RE: TEDS Exception No. 08-03, to Reduce Access Spacing at The Cottages at the Commons

## **DESIGN EXCEPTION #DE08-03**

Request to Reduce Access Spacing at The Cottages at the Commons

RE: Cottages at the Commons
Request for TEDS exception

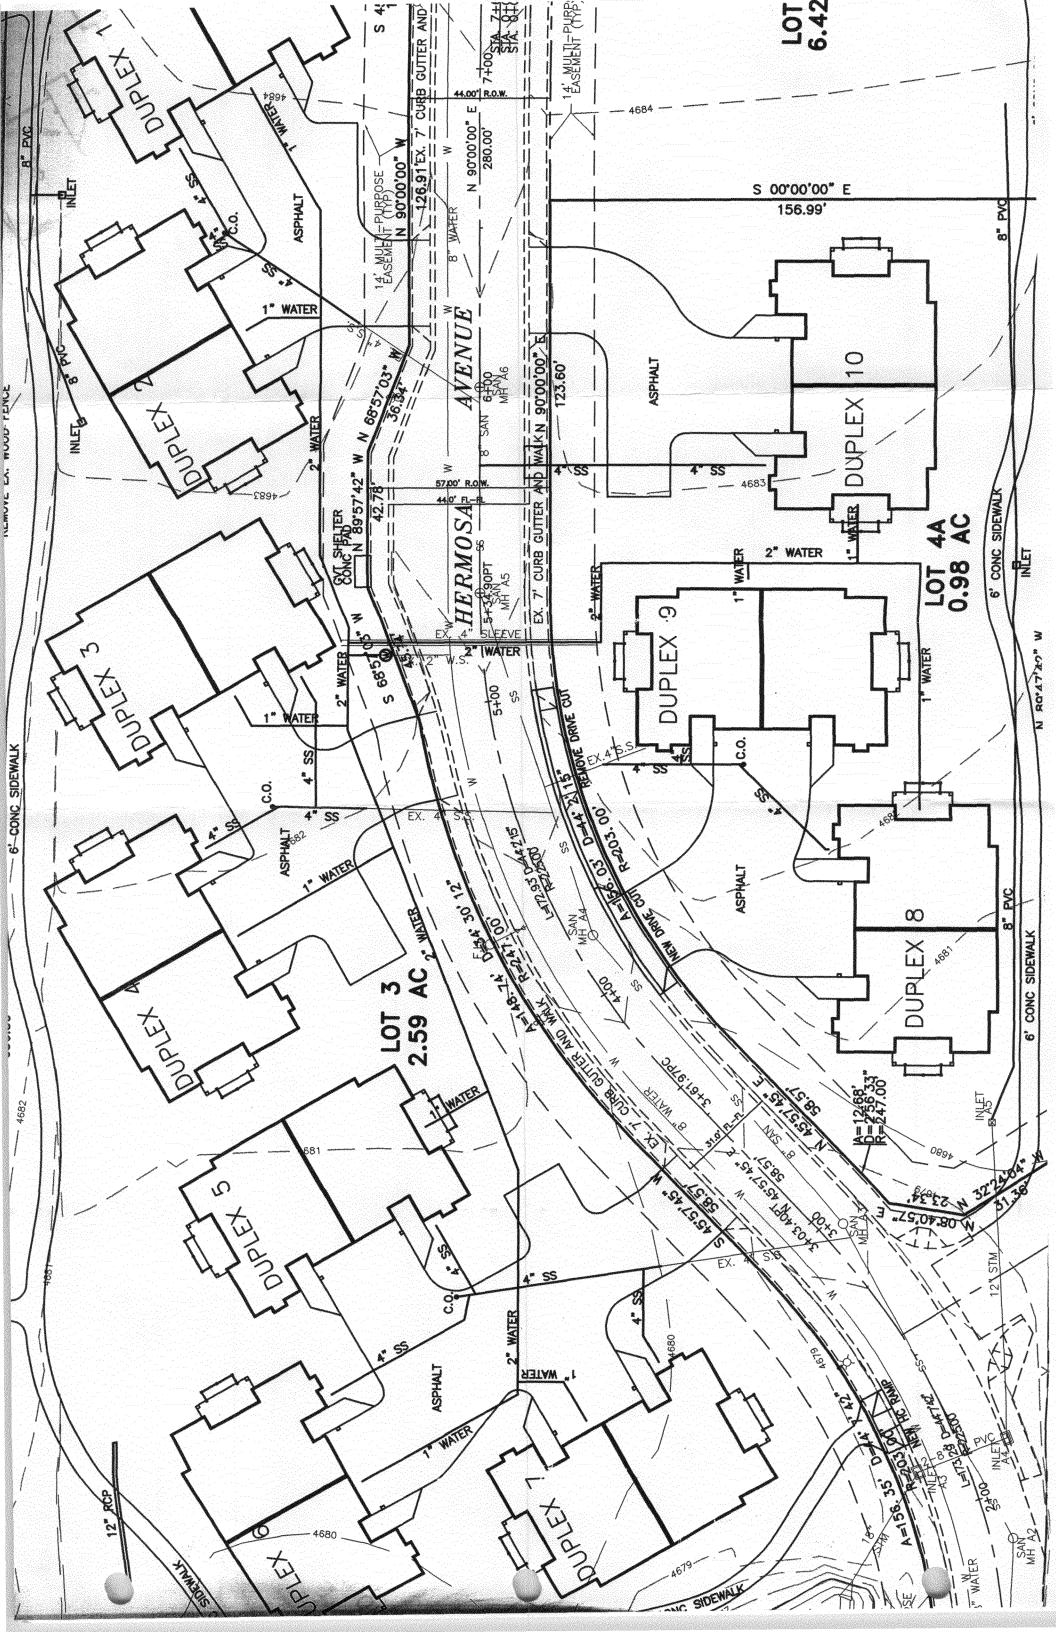
The proposed Cottages at the Commons project is located on both sides of the 1/8 mile section of Hermosa Avenue just east of 15<sup>th</sup> Street. The project consists of 10 duplex residential buildings arranged in clusters so that there is only five access points. The proposed layout utilizes three existing access points on the north side of Hermosa and two access points, one existing and one relocated, on the south side of Hermosa Avenue. The accesses were approved in 2001 with construction drawings for "The Commons". The eastern most access points on the north and south side lines up across from each other (within 2.4 ft). The remaining two access points on the north side are spaced at 152 feet apart. The western access on the south side of Hermosa Avenue is to be relocated to exactly in the middle of the two on the north.

This arrangement creates a situation where Section 4.1.2 of the TEDS is not satisfied. Section 4.1.2. reads "... the center of accesses and intersections not in alignment shall be offset 150 feet or greater on all collector and commercial streets..." An exception is here by requested to allow the center of accesses and intersections spaced at 75 feet or greater on this section of Hermosa Avenue.

It should be noted that there is a pending update to TEDS that states "... the center of accesses and intersections not in alignment shall be offset a minimum of 50' on local commercial streets..." This pending update recognizes the need for a transition between the spacing requirements for residential streets and the current 150' spacing requirement for "local" commercial streets and in particular for accesses of this type that were approved in 2001.

I recommend approval of the requested Design Exceptions to Section 4.1.1 to allow the three duplex accesses from Hermosa Avenue to be spaced approximately 75 feet a part, as long as they are designed to meet all other requirements of the TEDS.
